King's College Chapel, King's College, Cambridge – Installation of Solar Panels

Appendices to Historic England's advice

Appendix 1 - Reflectivity

View 1 -The south slope mock-up seen on the roof. Note the reflection of the turret, white cloud and blue sky.

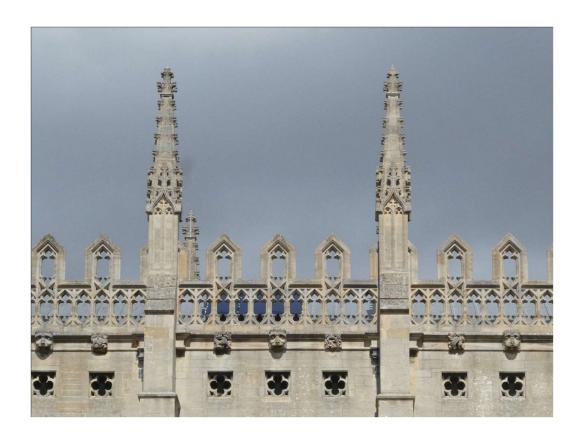
- 4. Our conclusion rests on our inspection of the sample installations which the College installed on both slopes of the Chapel roof. It was very clear, both when looking at the panels while standing on the roof and when looking at them from the ground, that they were reflective.

- 5. What we observed was that the panels "caught" the light from the skies above them. As the skies changed, so too did the panel's appearance. Sometimes they seemed the colour of lead and barely discernible against the lead roof covering and sometimes very dark, or almost black, or very light, or white.

Views 2 and 3 – Views of the south slope mock-up taken within two minutes of each other. Note the darkness of the panels in the first image and their lightness in the second. (In both views there is also a shadow gap at the panels' foot.)

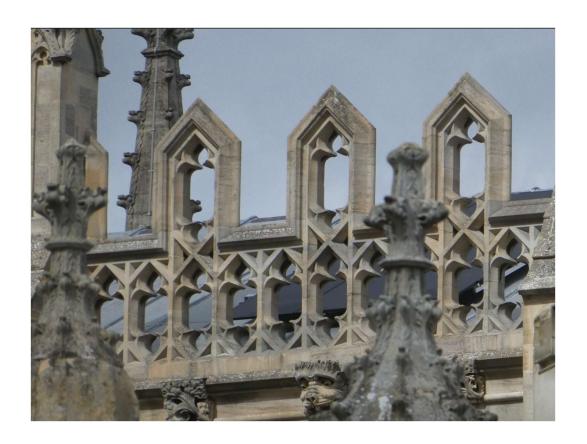
- 6. We viewed the panels beneath changing skies, in which clear blue was combined with moving clouds ranging from deep grey to light grey or white in colour and tone. The changes in the panels' tone and colour were observed to take places rapidly within a couple of minutes, for example as the sky changed.

Views 4 and 5- Views from King's Parade, illustrating the variability in the panel's colour. (These were taken on different days.)

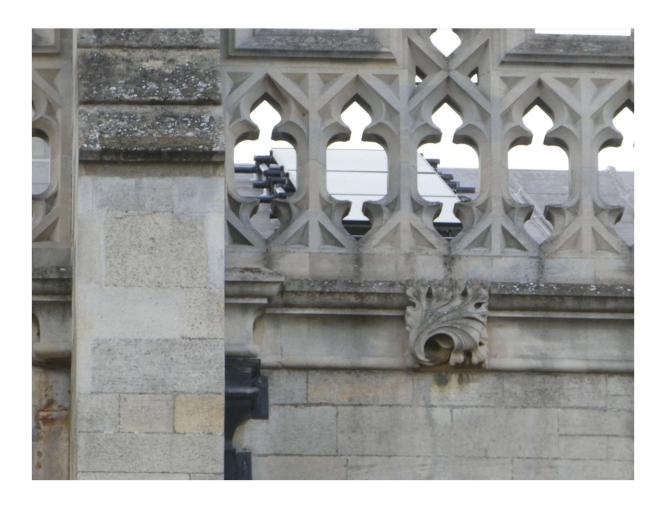
View 6 – View of the mock-up on the north slope, from Trinity Lane, Lane, illustrating the way in which the panel's "pick up" the brightness of a light sky.

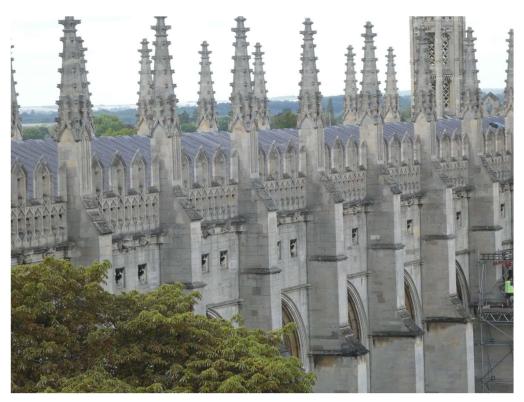
be reflected. It is likely that blue sky would simply darken the appearance of the panels from the ground, but in the important view from the tower of St. Mary's Church one would see the blue of a blue sky reflected, at least to some degree. The view to the north slope mock-up demonstrates this.

View 7 and 8 – View from the tower of St. Mary's Church. The north slope mock-up is visible at the far right, and appears a little blue – the second image is an enlargement to make the colour clear. The image also illustrates how from this important vantage point, the viewer sees much of the northern roof slope. (As noted above, the view is magnified, so does not represent what the eye sees.)
